Chapter 5

5-1– 12

FIGURE 504.1

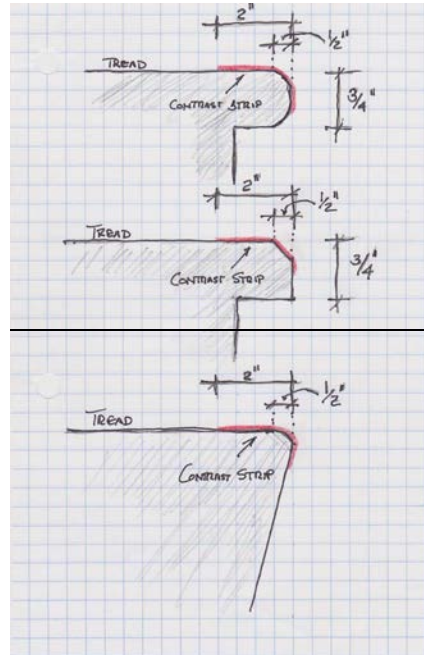
505.5.1.1 Every tread and landing shall have two surface colors for visual contrast, dark on-light or light-on dark.

505.5.1.2 The contrasting color of the leading edge of the tread or landing shall:

- a. Extend the full width of the tread or landing.
- b. Start at a line 2 inches (51 mm) back from the furthest point of the nosing and,
- c. Extend on the tread or landing toward the nosing, perpendicular to the path of travel, continuing to cover the profile of the nosing and down the riser until the color has extended 3 inches (75 mm) from the start line.

Reason: The concept in Proposal 5-13-13 has great merit, but the committee was unable to agree on adequate language to describe the contrasting edge stripe so that it is clear as to what is required. The proposed language and figure do that.
